A25368 – 22 & 22A Summit Drive, Mount Albert

RFI Response

CKL Reference	A25368
Filename:	A25368-TR-ITA-RFI Response
Site Location:	22 Summit Drive, Mount Albert
Author:	Chloë Davison Senior Transportation Engineer 
Reviewed and Authorised By:	Judith Matkinson Director 
Revision No.	2
Document Status:	Approved
Date:	15 January 2026

FIGURE 11 - 22 SUMMIT DRIVE - GARAGE DOOR DIMENSIONS

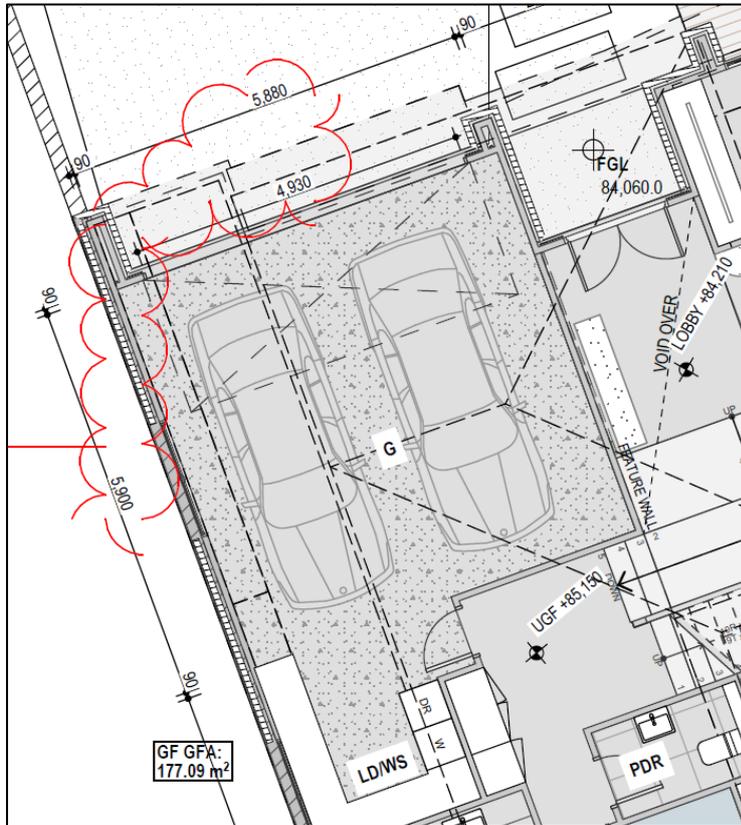
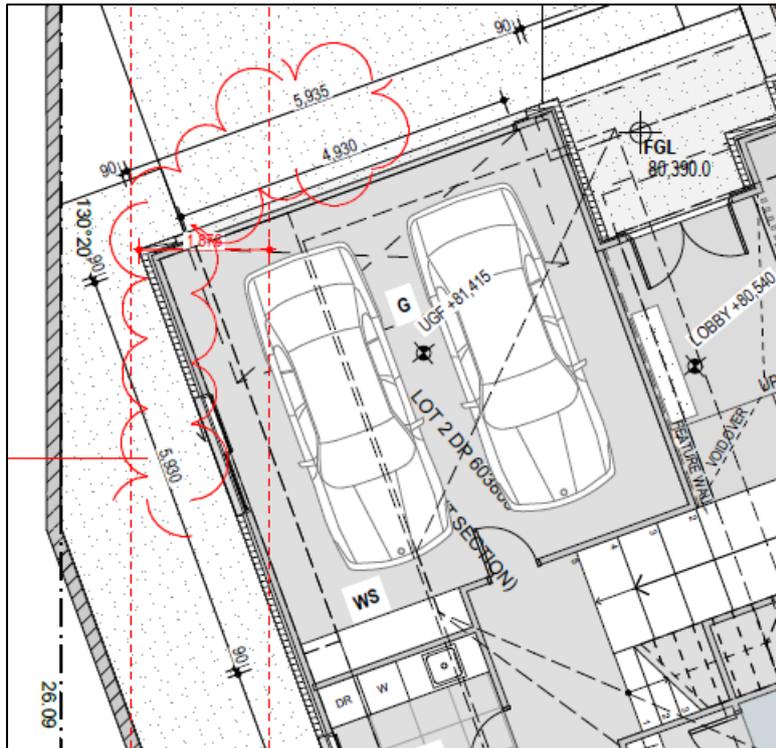
13. Please clearly show on the plans dimensions for the proposed car parking spaces.

The proposed car parking spaces are located within the garages, with a depth of 5.9 m, a total width of 5.88 m (2.9m per space), and a garage door opening of 4.93 m. The dimensions are shown within the architectural drawings prepared by 10x10 dated November 2025 and shown in Figure 11 and Figure 12.

The dimensions are considered appropriate to cater for two vehicles within a double garage. It is further noted that the dimensions comply with development control T120 of the Unitary Plan that stipulate that for car parking spaces that are 2.7m wide and 5.0m long, a manoeuvring aisle depth of 5.9m is required. There is in excess of 8.0m manoeuvring aisle available for both 22 and 22A Summit Drive and as such the car parking space dimensions comply with the requirements of the Unitary Plan. The dimensions supported with the vehicle tracking analysis demonstrate that the proposed car parking spaces can operate safely and efficiently.

FIGURE 15: PROPOSED CONVEX MIRROR AND SPEED BUMP LOCATIONS

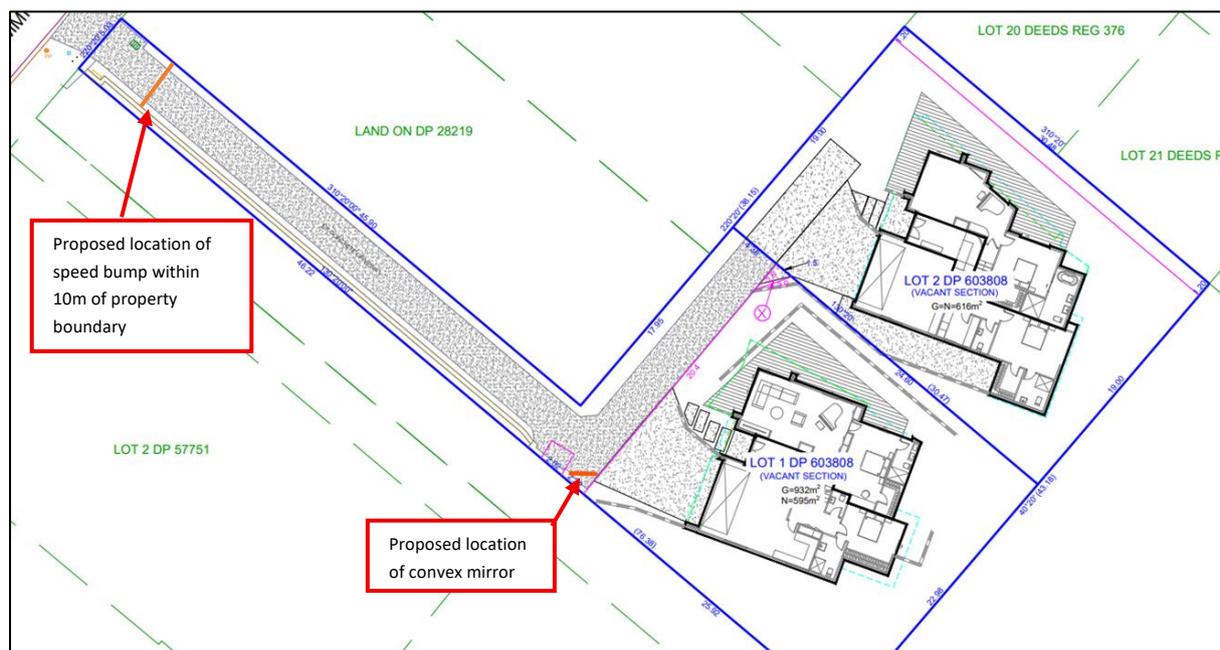
17. Proposed access is shown to be greater than 50 m. A passing bay is required as per E27.6.4.3.1. Please provide an assessment of effects for the non-compliance and appropriate mitigation for this.

There is 50.0m between the property boundary and 22 Summit Drive and constructed vehicle access and therefore the straight one-way section does not exceed 50.0m. Nevertheless, there is space within the driveway of 22 Summit Drive in front of the proposed garages, for an occupier at 22 Summit Drive to stop and wait for an incoming driver. Similarly to Item 10 and Item 16, driveway width and passing bay requirements would have been assessed under the R/SUB/2016/743 application.

It is further proposed to provide a small 450mm wide convex mirror at the corner of the L shaped driveway to provide intervisibility along the length and to assist with drivers' decision making.

From an operational perspective, potential conflict on the driveway has been further analysed in order to respond to Council's RFI. The existing driveway will provide access to 4 car parking spaces and the length of the one-way section is 50.0m. Operational speeds are low and are estimated to be 5-10km/h. Therefore, time on the driveway would be between 18 seconds and 36 seconds. Furthermore, given the low car parking provision and adopting a rate of 1.3 vehicles per hour per dwelling in the peak periods (based on the New Zealand Transport Agency Research Report 453), and a directional distribution split of 80% and 20% during the peak periods, using a Poisson distribution, the probability of at least one departure and one arrival within 36 seconds is 0.0107%. There is therefore a low probability of drivers meeting on the one-way section of the driveway and if two drivers travelling in the opposing directions do meet on the driveway, drivers will give-way accordingly.

Overall, given the low probability of conflicting movements on the driveway and the provision of the convex mirror, the effect of not providing a passing bay from a safety or operational perspective is negligible.
